RESPONSE TO COUNCIL INFORMATION REQUEST IN RELATION TO THE REEF MARINA REDEVELOPMENT – COMBINED APPLICATION

The following response is provided to Council's Information Request (IR) issued by correspondence dated 30 November, 2016.

PROJ NO. 160303	DWG NO. DA-S-108	REVISION: 03
STATUS: DEVELOPMENT APPLICATION

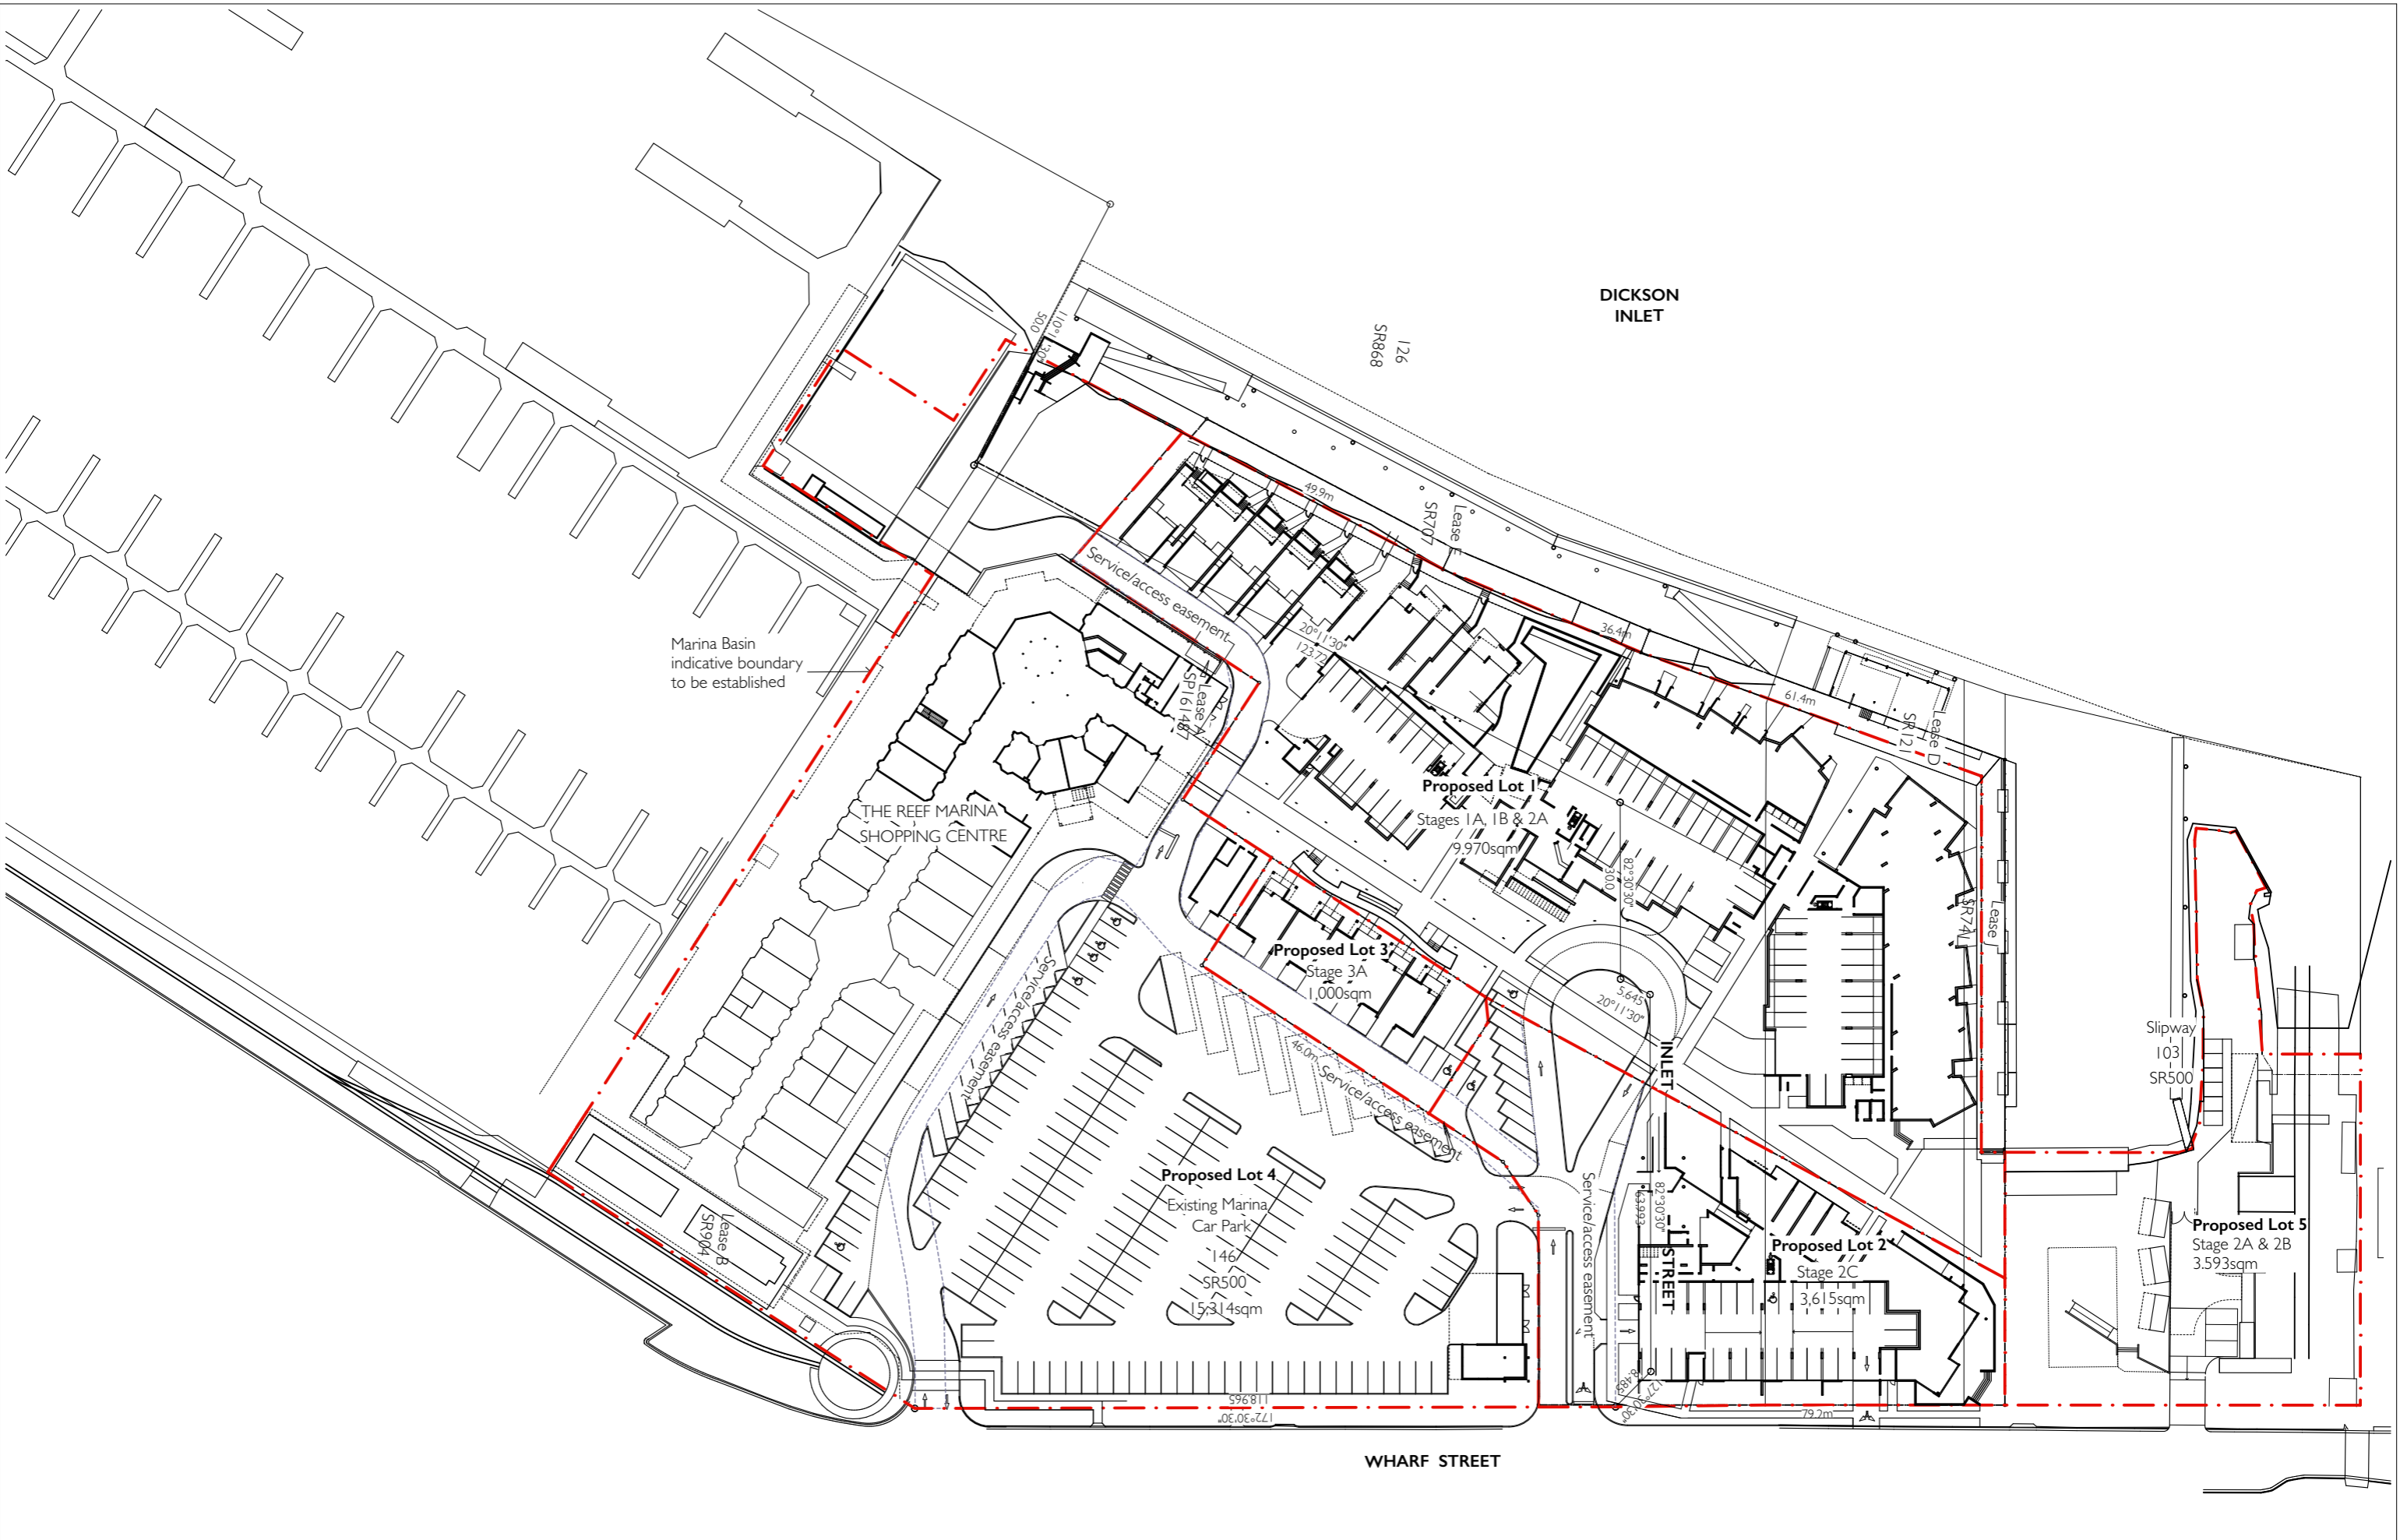
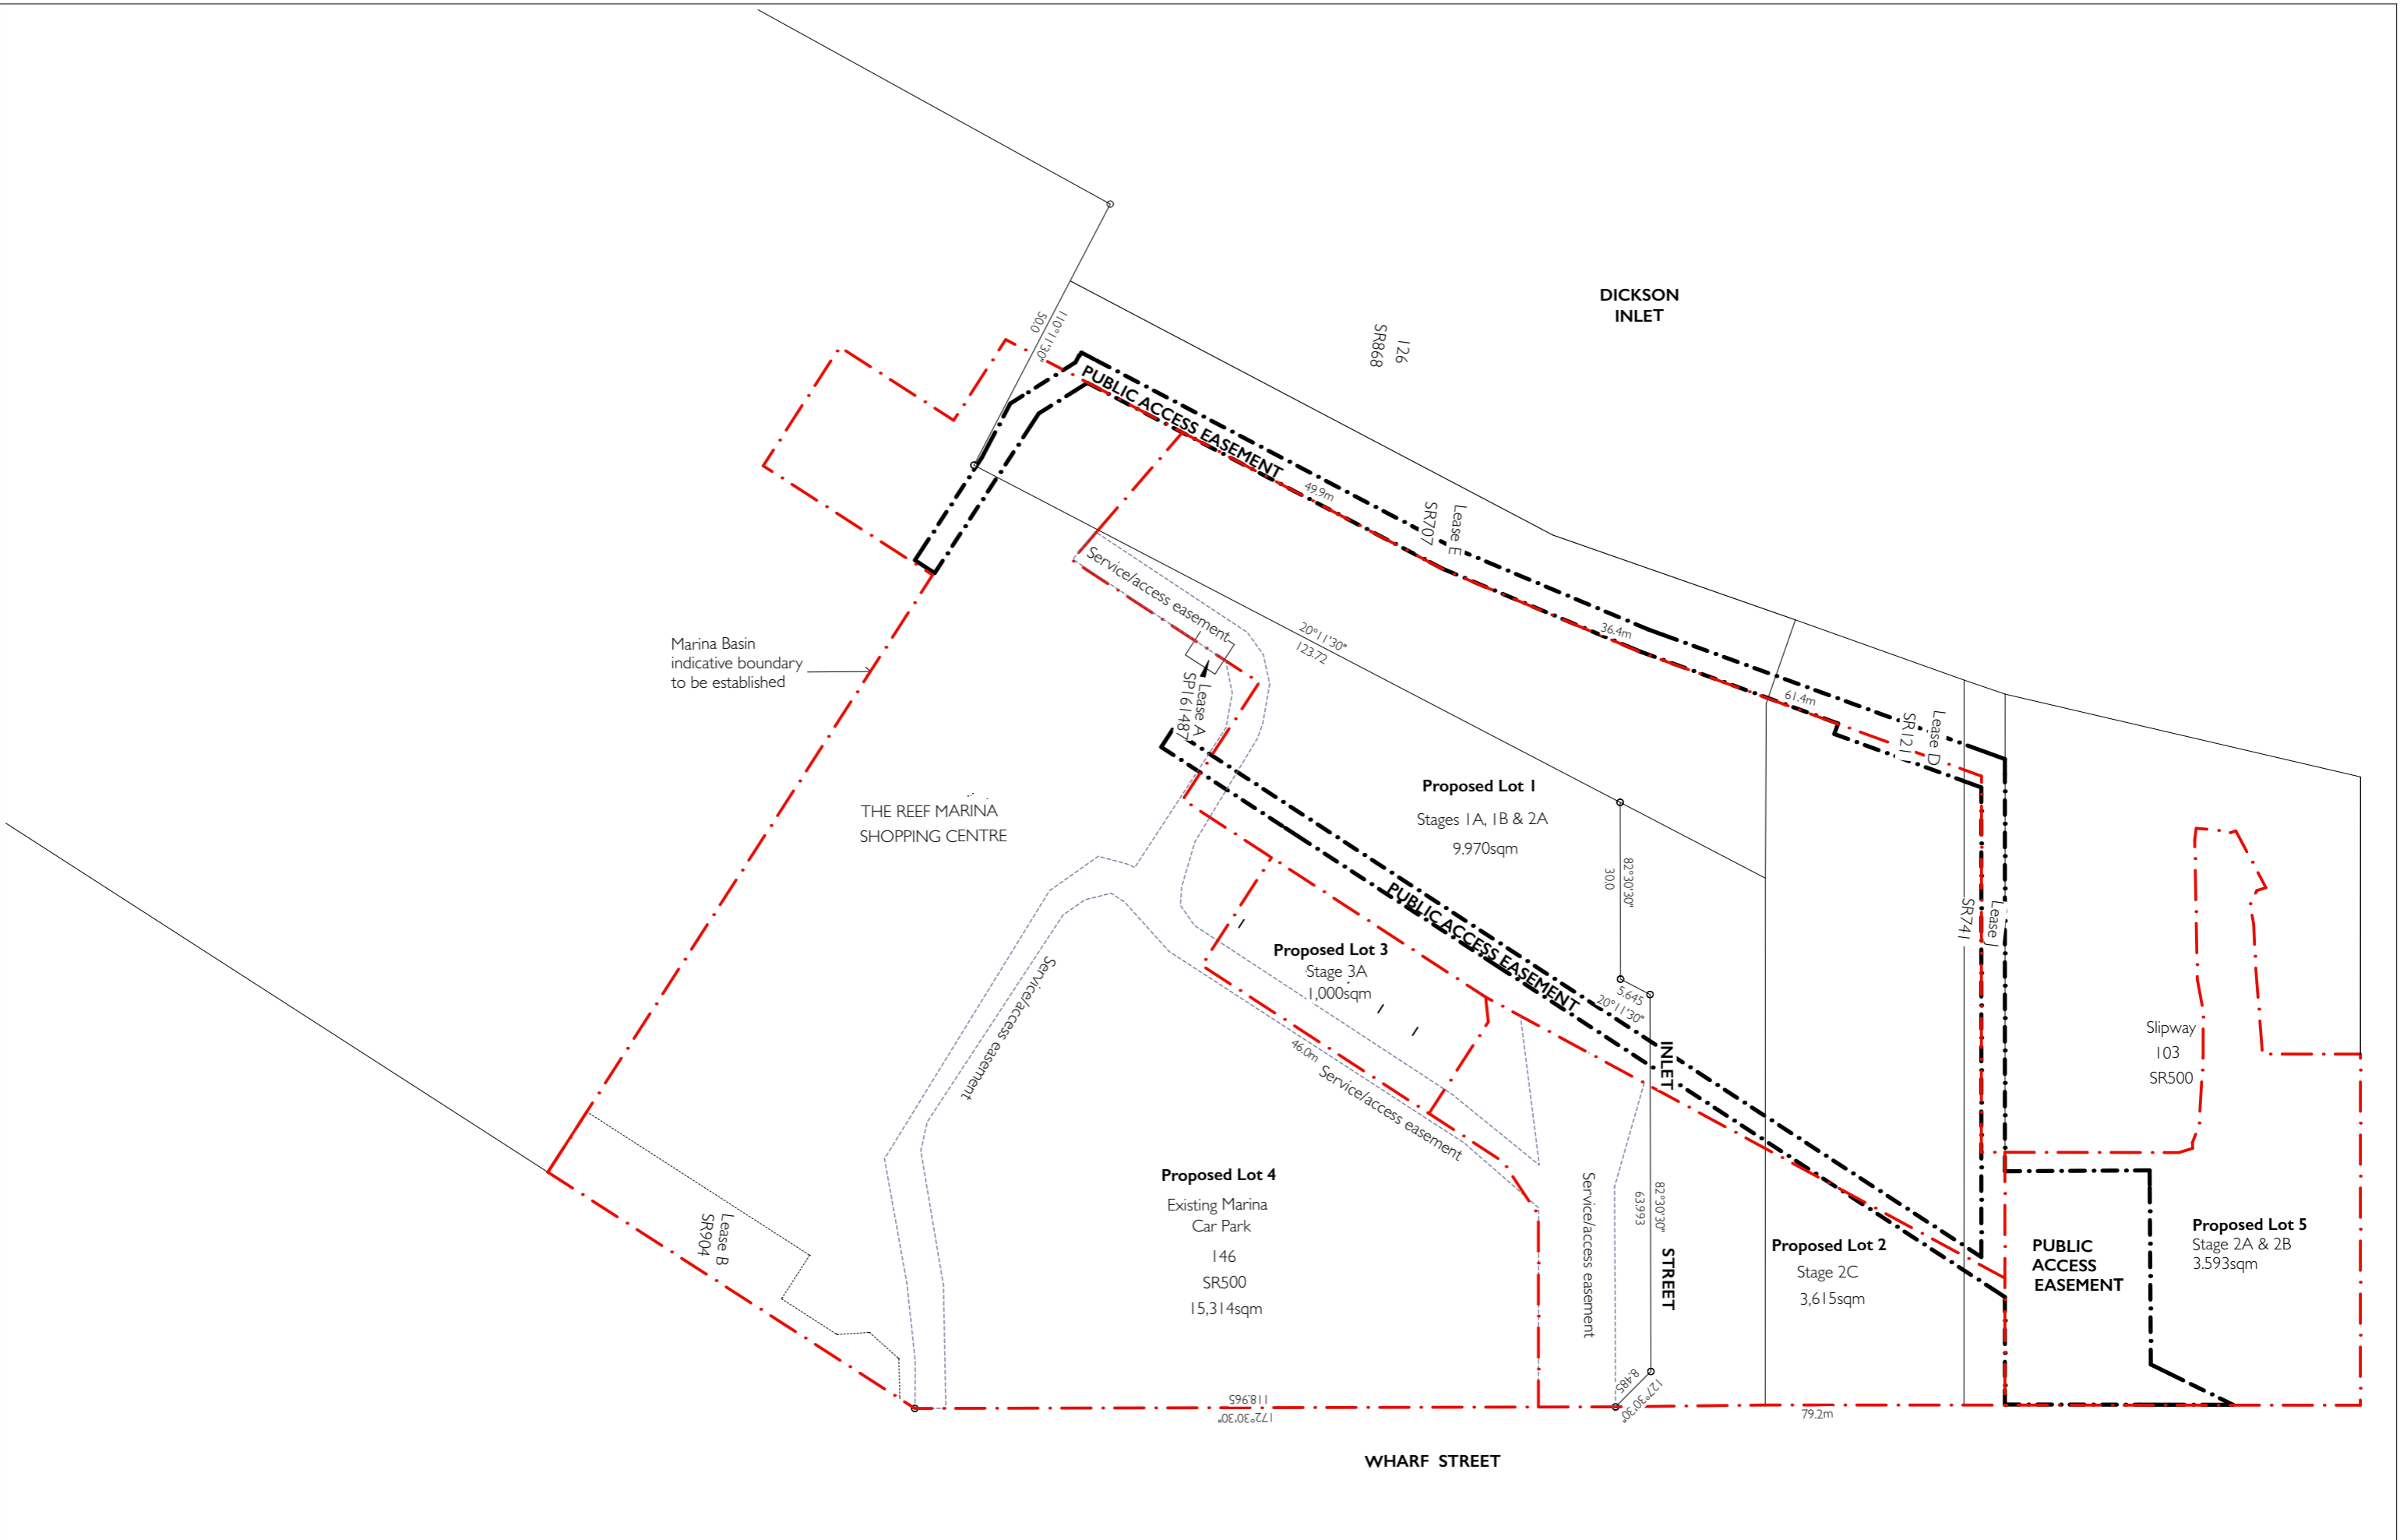
4. Please provide a Lot Reconfiguration Plan that clearly identifies individual lots and proposed easements. Preliminary Approval has not been addressed with respect to the provision of general public access easements (or similar) across the site to provide public waterfront access.

Furthermore, please supply the revised Lot Reconfiguration Plan distinctly overlain on top of the overall Master Plan for clarity.

The Lot Reconfiguration Plan, drawing DA-S-108 Revision 3 and Reconfiguration Plan/Master Plan Overlay, drawing DA-IR-109, Revision 3 are attached at Appendix 3.

Drawing Title
**TURN PATH PLANS
 Sheet 2**

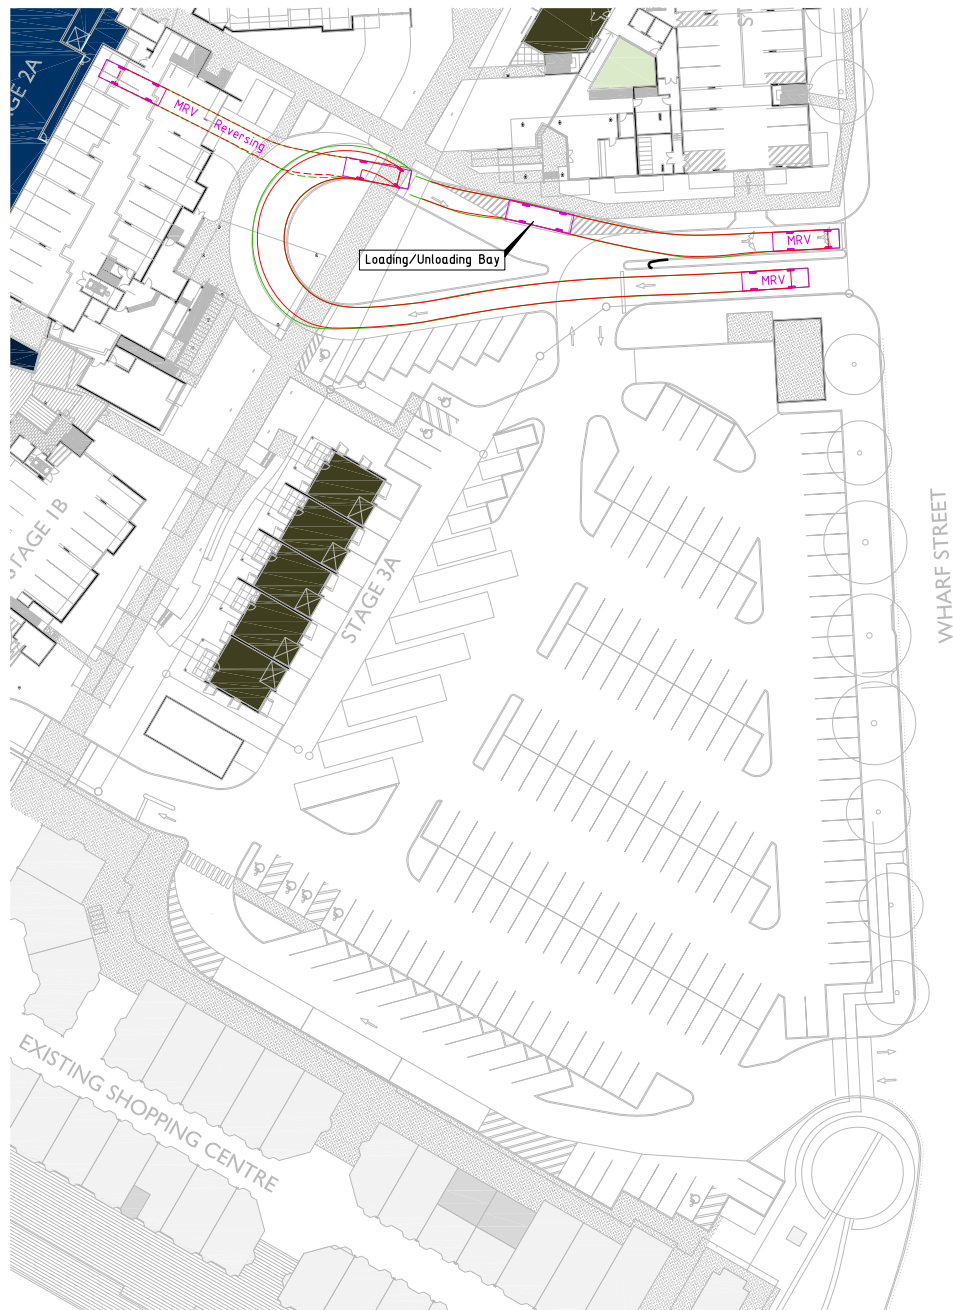
20. Identify the servicing delivery arrangements for the commercial component.

29. Identify the Goods Receiving Area (REC) and the service delivery arrangements for the Commercial component.

A loading/unloading bay has been located on Coral Close to service the commercial area. Refer to PDR letter dated 30 November 2016 and attached Sweep Paths, attached at Appendix 10.

A loading/unloading bay has been located on Coral Close to service the Stage 2C commercial area. Refer to PDR letter dated 30 November 2016 and attached Sweep Paths attached at [Appendix 10](#).

We advise that it was always the intent that goods for these areas would be unloaded at the loading/unloading bay provided on the internal private service road. The location of this bay is shown on our attached drawing 16470 SK-TP02. Goods can be unloaded at this point and taken by trolley (or carried) to any of the business locations.

The bay caters for a medium rigid vehicle (MRV) and the attached plan shows the vehicle path and demonstrates that it can enter and leave the bay without disrupting other traffic. The swept paths also demonstrate that an MRV can easily negotiate the loop road. It is anticipated, given the type of operations considered, that this would be the maximum delivery vehicle size. Chevrons have been provided to prevent other vehicles parking in the vicinity of this bay and preventing access.

Should the need arise, the swept path diagram also demonstrates that an MRV could reverse into the stage 2A carpark and leave in a forward gear. This movement would be the exception and only carried out early in the day or if the parking bays were available for a short term.
